Daeyu Bangladesh LTD (Extension)

731, Bhannara Mouchak, Gazipur.

02 May 2023

Observations

Current roof

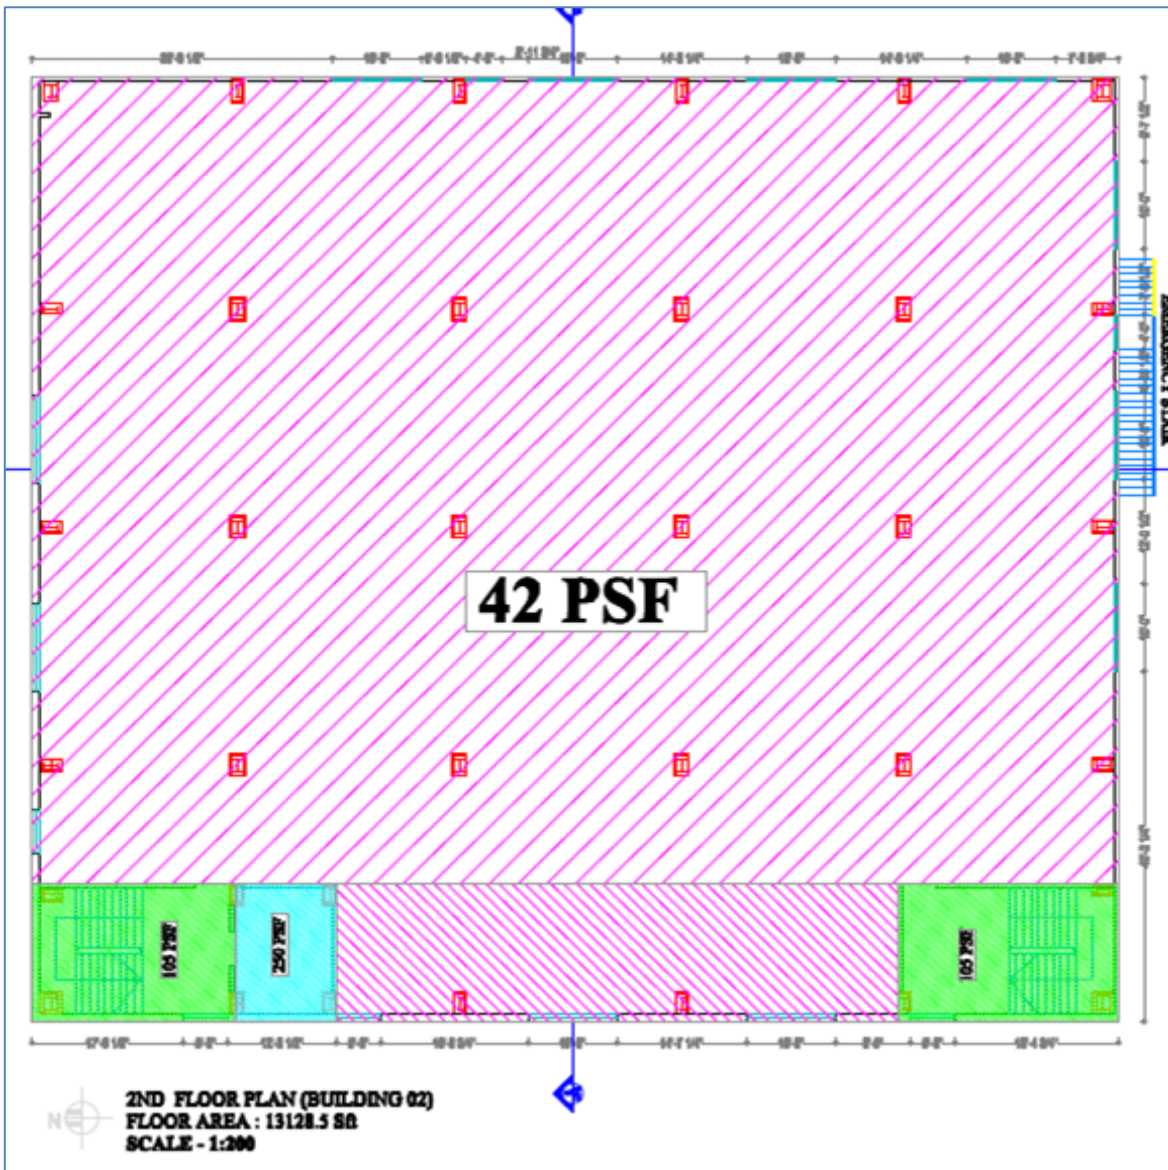
Lack of construction safety measures

Necessary safety measures were not observed on the roof. No barrier was provided at roof to mitigate the falling hazard. Building engineer is required to take necessary measures to provide and install construction safety barrier.

Floor loading

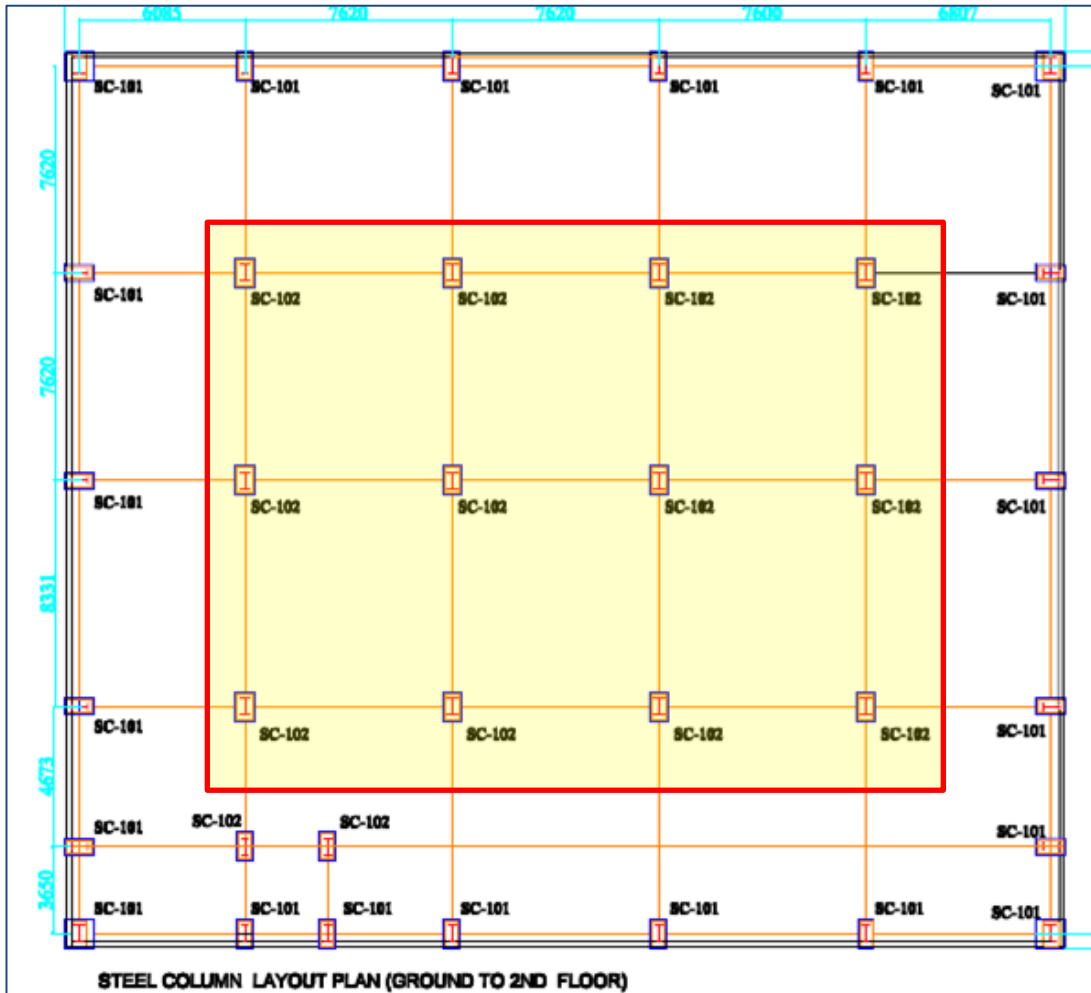
Overloading on the floor

As per load plan and provided design report the building is design for 42 psf live load on typical floor. But during the inspection floor loading was found almost 84 psf in storage areas.

Building engineer is required to be revised the floor load plan considering floor slab, Column and footing capacity.
